Item Name: Seat Structure Assembly

DRAWING NO. D3016	TITLE SEAT FRAME ASSEMBLY	REV. A	DART AEROSPACE LTD ENGINEERING ORDER	D.E.O. NO. D3016-A-1	SHEET NO. SHEET 1 OF 1	SCALE NTS
DRAWN <i>8</i>	CHECKED <i>UP</i>	MFG. APPR. <i>RE</i>	APPROVED <i>WAP</i>	DE APPR. <i>WAP</i>		
DATE 10.01.29	DATE 10.01.29	DATE 10.01.29	DATE 10.01.29	DATE 10.01.29

PURPOSE:

TO REVISE D3016-11 SADDLE'S HOLE SIZES

D3016-11 SADDLE

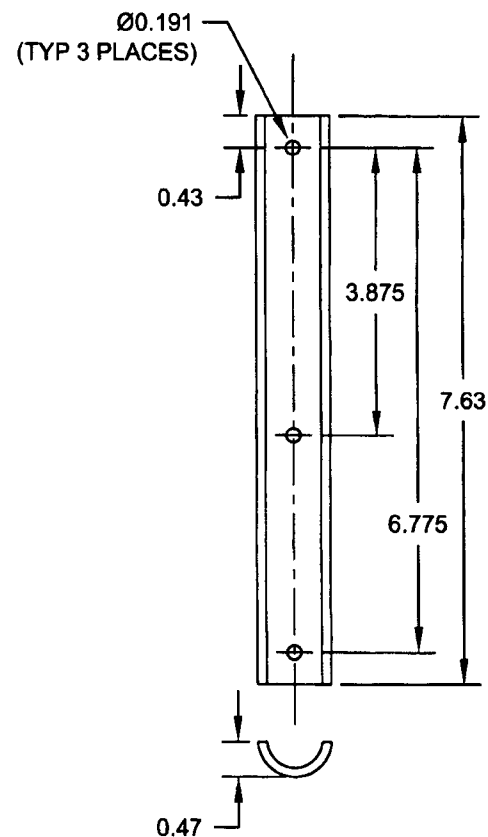
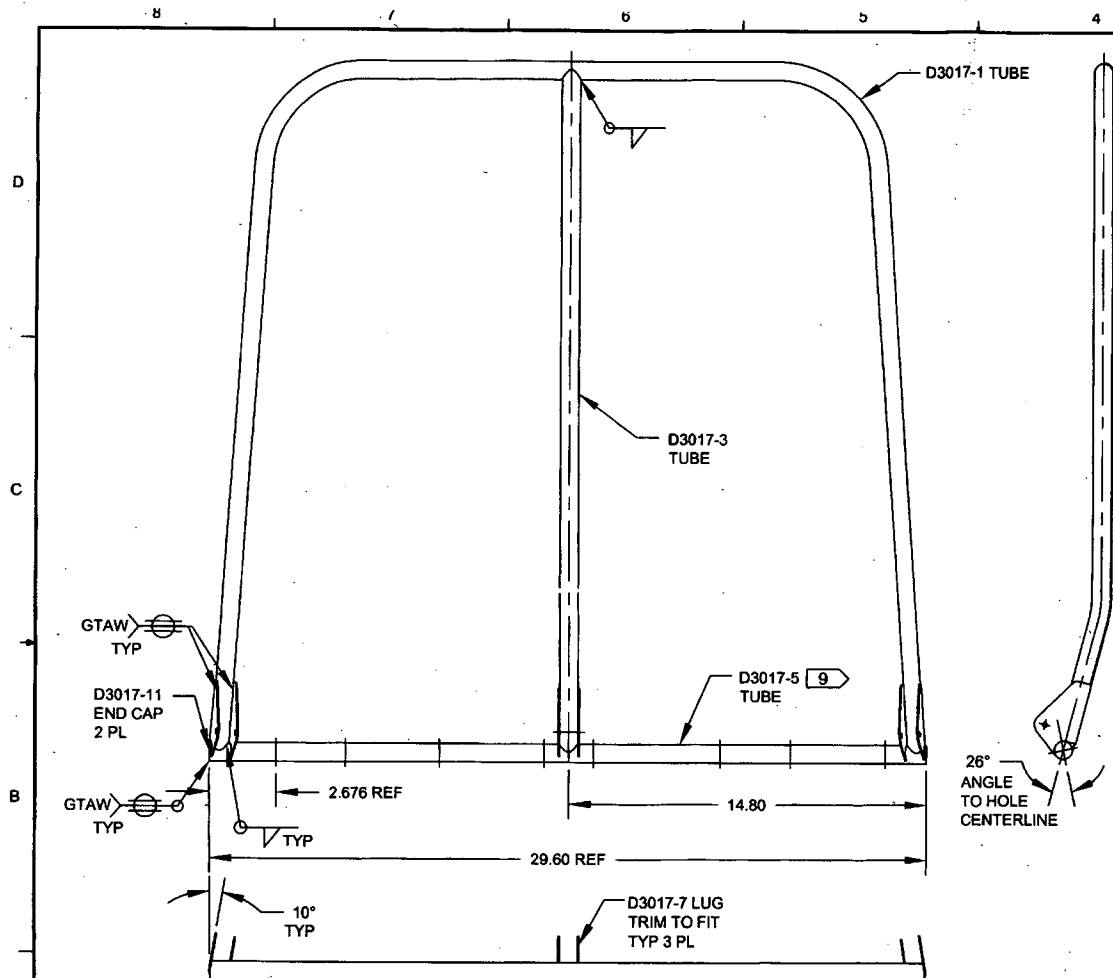
DETAIL D3016-11 SADDLE (SHEET 3): Ø0.257 TYP 3 PL WAS Ø0.191 (TYP 3 PLACES) AS SHOWN:
